Stonehouse Farm – Lot 8: Public Rights of Way

Ref: ITS19302-002
Date: 19 May 2025

Image 2.1: FP 1708 Alignment

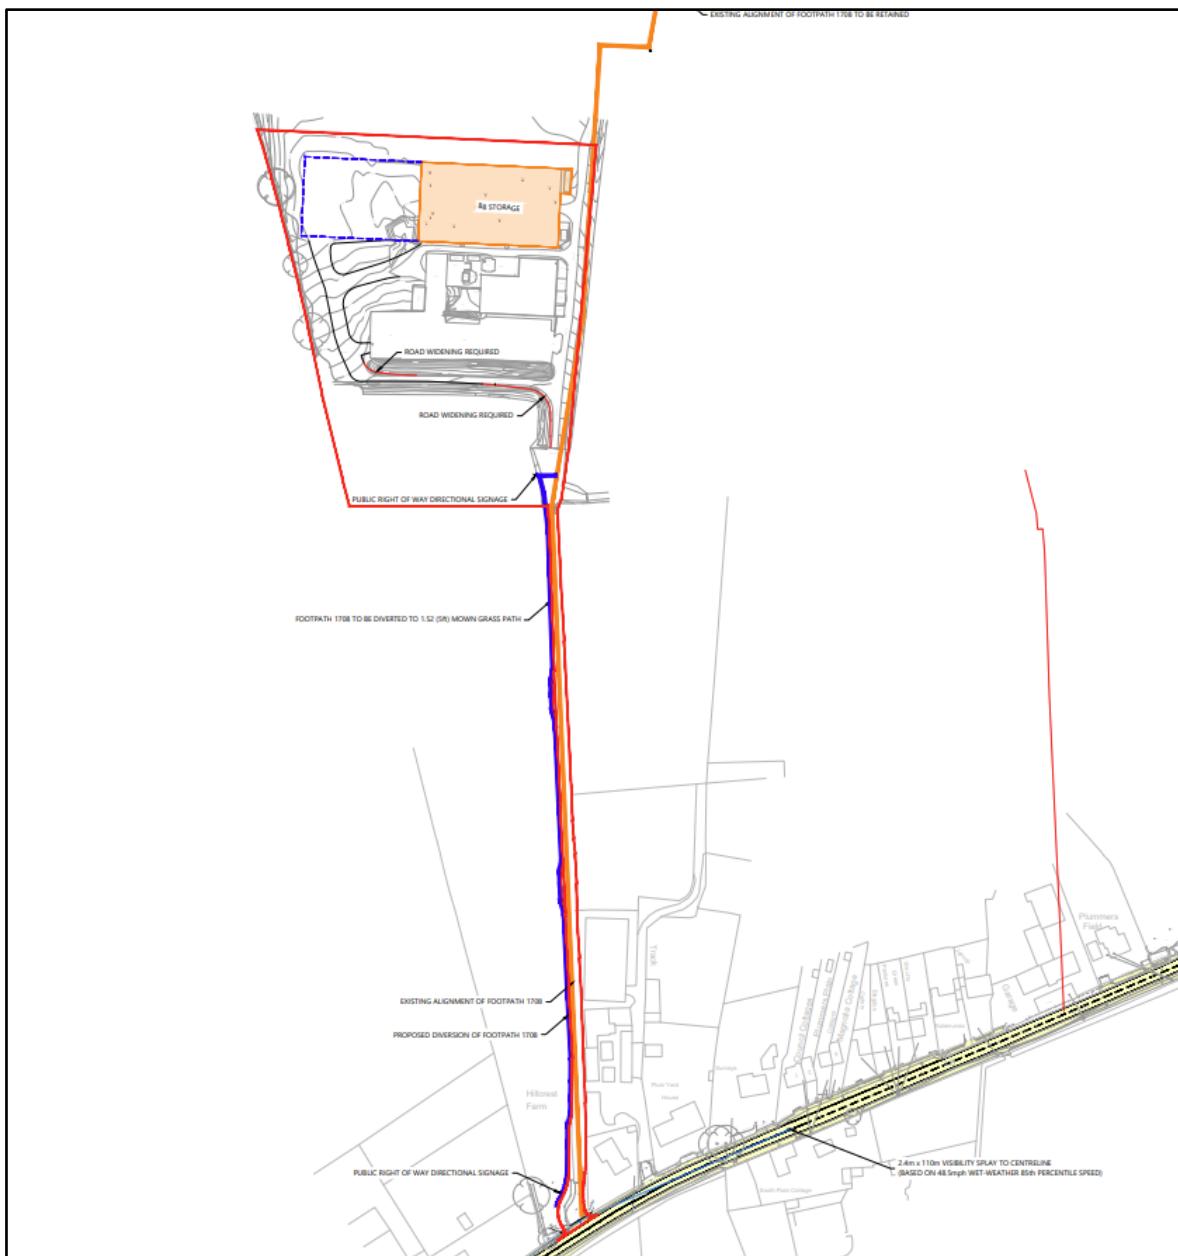
- 2.1 Public Right of Way Footpath 1708 runs north – south through the site, providing a link between the B2110 and Hammerpond Road, as shown in **Image 2.1**.

Image 5.1: Crossing Arrangement Extract

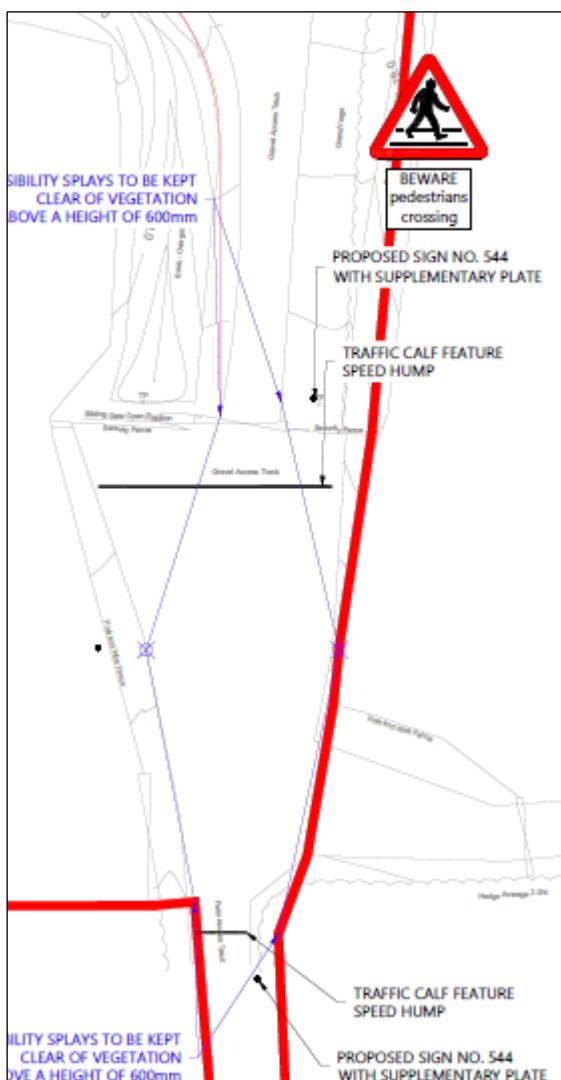
5.2 Notwithstanding, advice has been sought from the WSCC Public Rights of Way Officer in respect of the treatment sought at the crossing point. The following was requested:

- Visibility splays to be kept clear of obstruction (e.g. vegetation) and maintained.
- A speed bump / traffic calming feature on the approach to the crossing.
- The provision of signage to reinforce the presence of pedestrians crossings.

5.3 On that basis, an inset is provided on drawing ITS19302-GA-013D showing the supplementary works. At the crossing point, visibility splays are identified and vegetation will be maintained below a height of 600mm. Pedestrian crossing signage and supplementary warning plate, consistent with the DfT Traffic Signs Regulation and General Directions document, are provided on both the north and south-bound approach to the crossing.

5.4 In addition, speed humps are shown to both the north and south of the crossing to slow vehicles on the approach. However, to the north of the access, the access to the site is currently gated – should this gate remain in situ, a speed bump to the north of the crossing will not be provided given that vehicles will be required to wait at the gate when exiting, already reducing their speed. Should the gate be removed as part of the planning process, then the speed bump will be provided.

5.5 An extract of the arrangement is shown in **Drawing 5.1**.
